# DETAILED CONSERVATION COMMISSION AGENDA

Date: Thursday, January 27, 2022

### 1. (7:00) 152 Suffolk Rd – NOI – backyard pool, sports court, patio, and greenhouse – DEP #239-911

**5. (8:15) Hammond Pond Parkway – NOI – roadway and corridor improvement -- DEP #239-???**

PROJECT FILE NO. -  
LANDSCAPE PLANS 9  
NOTICE OF INTENT PLAN SET

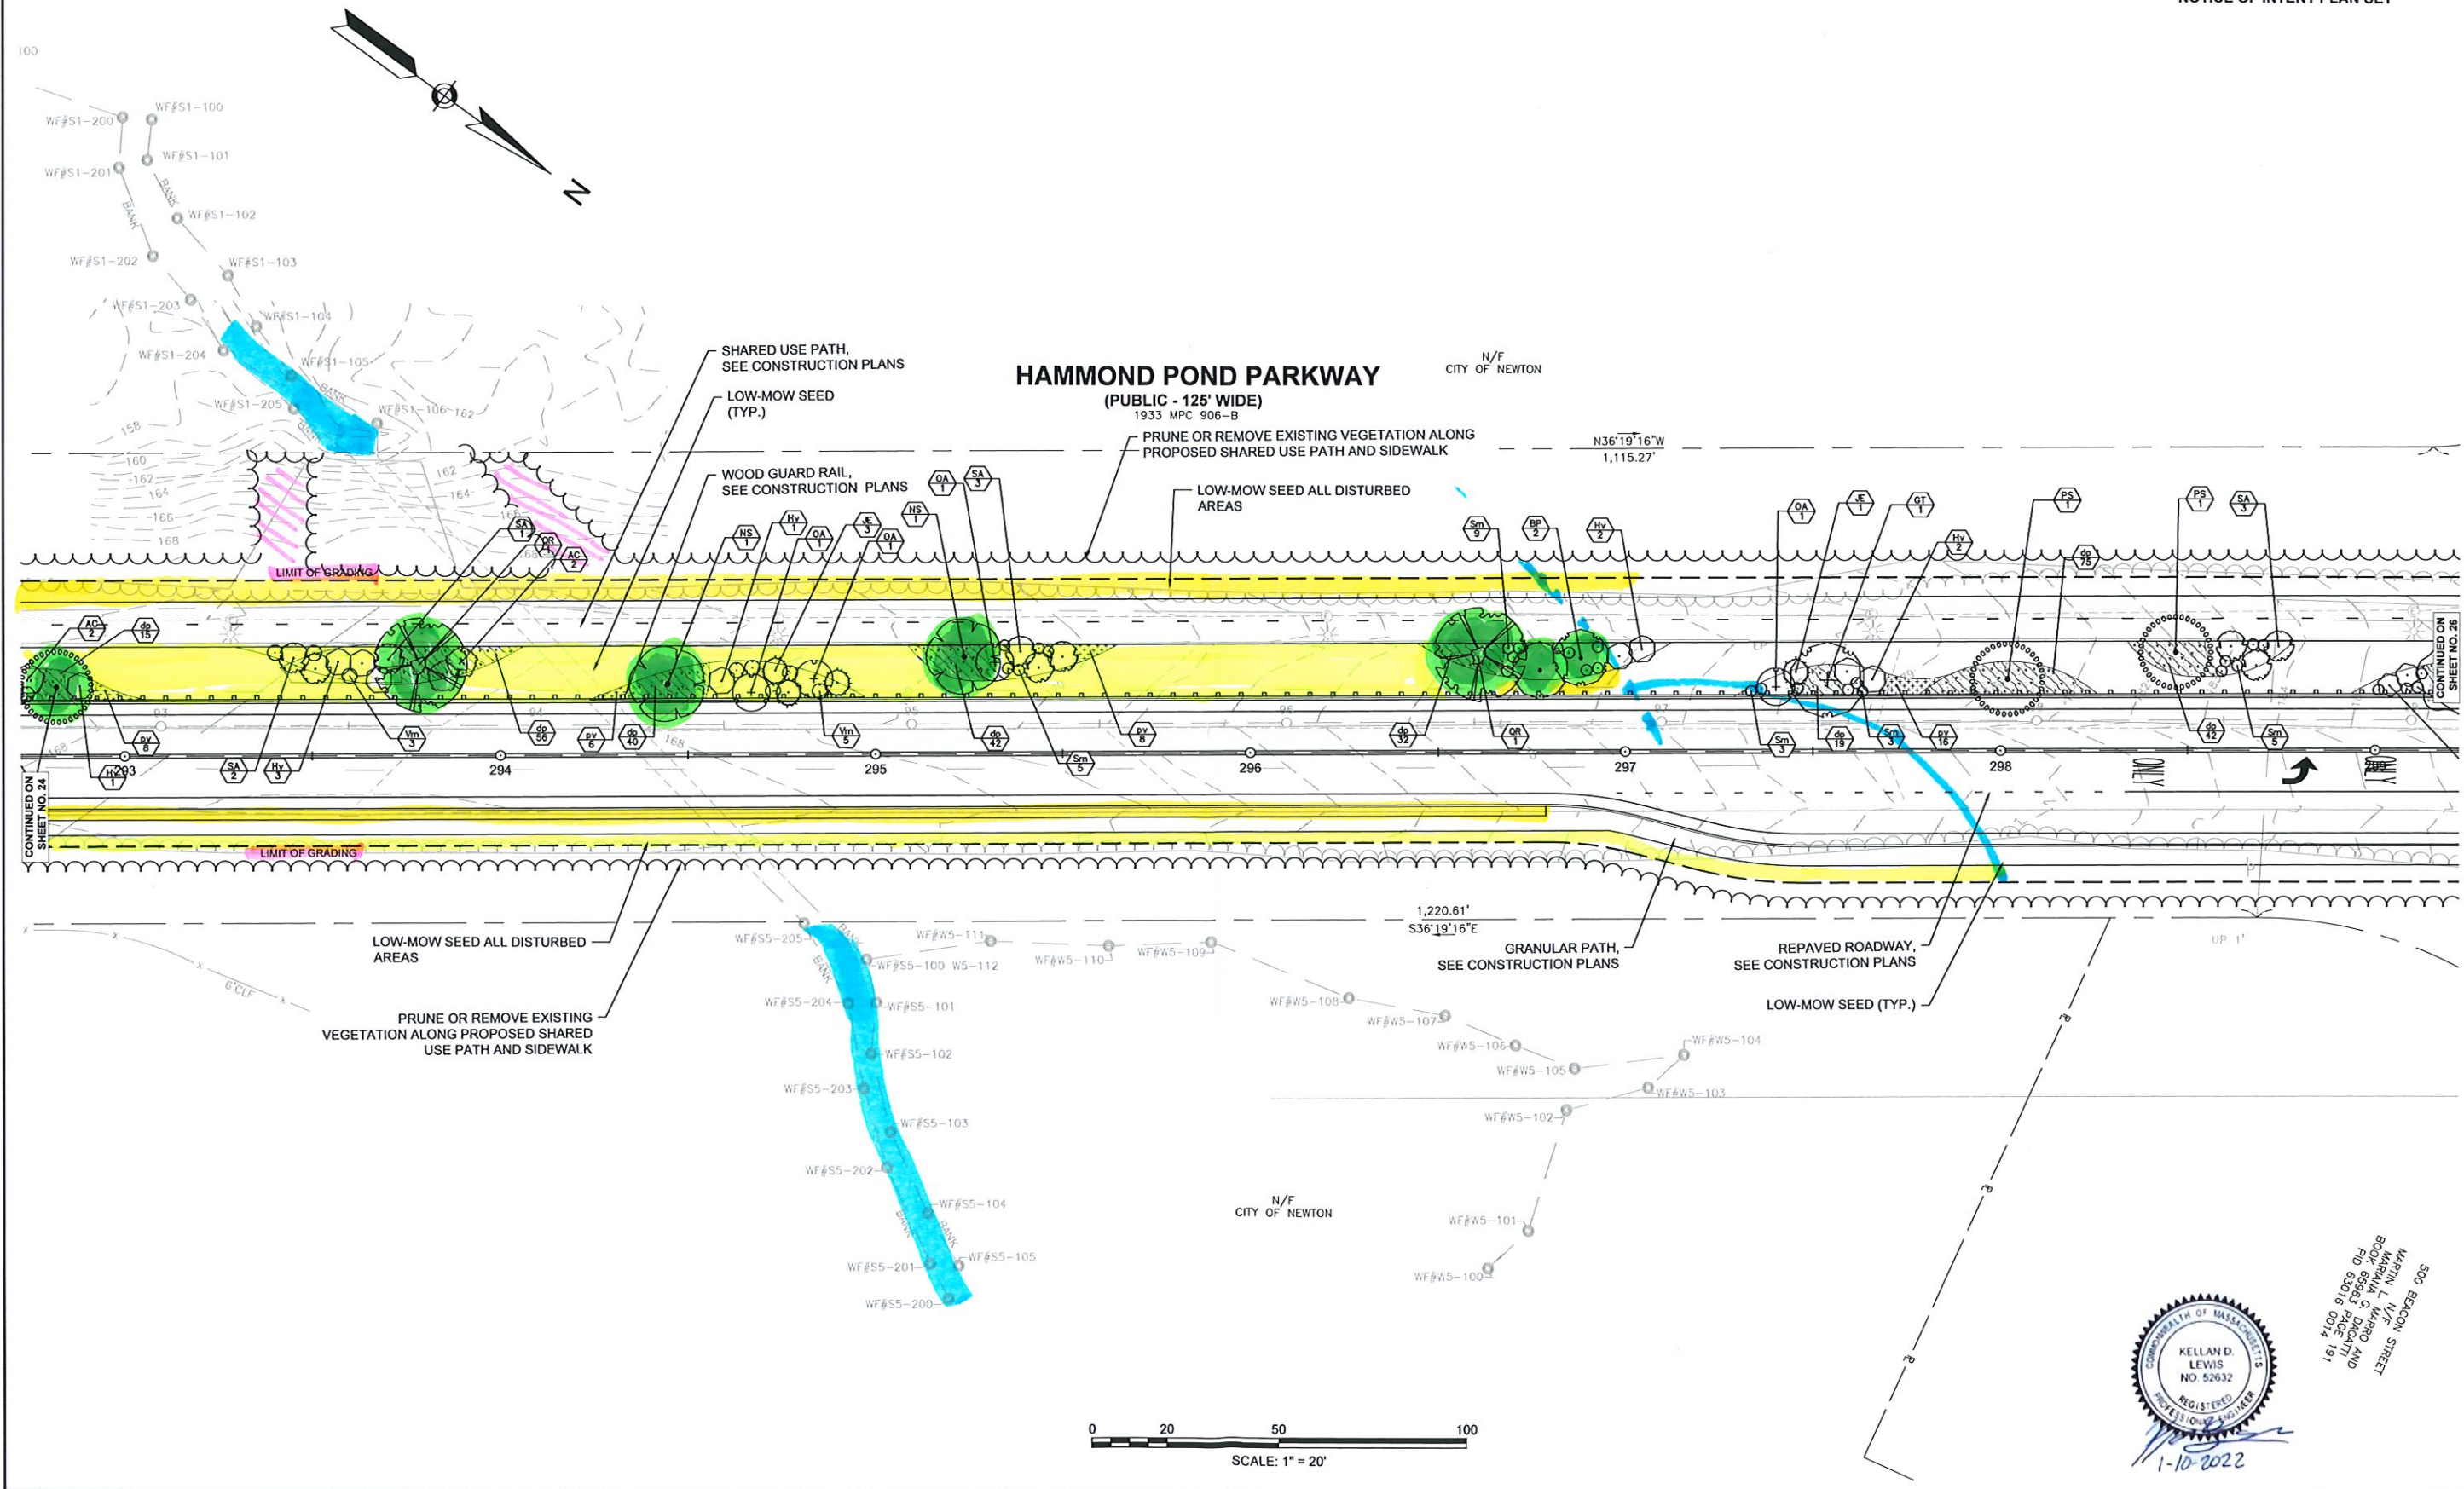
- There will be significant grading at the northeast corner of the new parking area, yet no new grade lines are shown and it appears that insufficient space is provided for side slopes. How will this area be addressed?
- On Landscape Plan sheet 5 there is a “limit of grading” label that appears to be on the property line. It should be removed.
- There is no erosion control/limit of work shown that would protect the “island of trees” near Hammond Brook. That should be added.
- Will there be any invasive control efforts?
